Access Compliance Report Public Rights-of-Way (Curb Ramps)

Main Street: SIENNA_PKWY		Cross Street: N_DAISSY_ST		Location:	N
ADA ID: RPRK211110130139	Ramp Type:Type 1 - Perpendicular	Initial Pass/Fail: Fail	Overall Compliance: No	Severity Score:	16

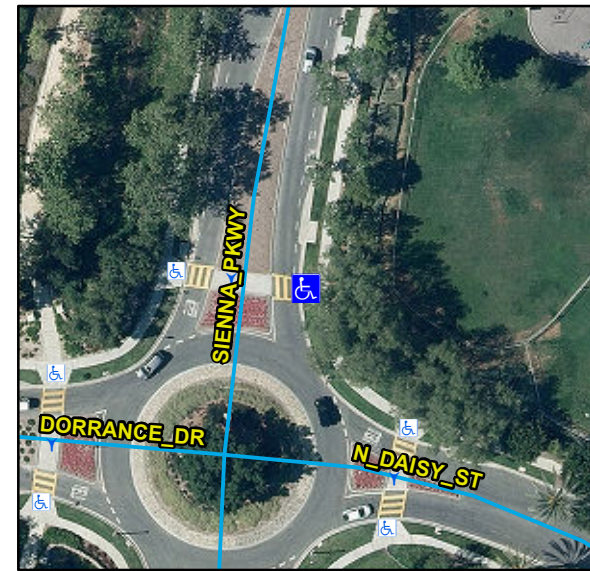
Compliance	Description	Data	Compliance	Description	Data
N/A	Ramp Length (in)	90	N/A	Flare Type LT	
Yes	Ramp Width (in)	48			N/A
No	Ramp Run Slope (%)	8.8	N/A	Flare Slope LT (%)	N/A
Yes	Ramp Cross Slope (%)	1.9	N/A	Flare Traversable LT	N/A
N/A	Landing Present	N/A	N/A	Flare Type RT	
N/A	Landing Length (in)	N/A			N/A
N/A	Landing Width (in)	N/A	N/A	Flare Slope RT (%)	N/A
N/A	Landing Run Slope (%)	N/A	N/A	Flare Traversable RT	N/A
N/A	Landing Cross Slope (%)	N/A	N/A	DWS Provided	N/A
N/A	Landing Movement Obstructed?	N/A	N/A	DWS Contrast	N/A
	Landing Movement Type	N/A	N/A	DWS Length (in)	N/A
N/A	Landing Shared	N/A	N/A	DWS Full Width	N/A
N/A	Clear Space	N/A	N/A	DWS Offset Left (in)	N/A
N/A	Clear Space To Crosswalk (in)	N/A	N/A	DWS Offset Right (in)	N/A
N/A	Marked Crosswalk 1	Yes	N/A	Marked Crosswalk 2	N/A
	Crossing 1 Direction	W		Crossing 2 Direction	N/A
	Marked Crosswalk 1 Width (in)	144		Marked Crosswalk 2 Width (in)	N/A

N/A	Ramp Inside Crosswalk 1	Yes	Yes	Ramp Inside Crosswalk 2	N/A
	Crossing 1 Slope (%)	3.3		Crossing 2 Slope (%)	N/A
	Crossing 1 Cross Slope (%)	0.5		Crossing 2 Cross Slope (%)	N/A
N/A	Gutter Ponding	N/A	No	Curb Slope	8.6
Yes	Gutter Lip Height (in)	0		Road Run Slope (%)	N/A
N/A	Gutter Run Slope (%)	N/A		Road Cross Slope (%)	N/A
N/A	Gutter Cross Slope (%)	N/A			
Yes	Overall Surface Condition: Acceptable		No	Perp Joint Present	No
	Cross Gutter Present?	No		Spandrel Present?	No
	Replace Cross Gutter?	N/A		Replace Spandrel?	N/A

Remove & Replace Entire Ramp.

R304.2.2, R204.3, STD 1115
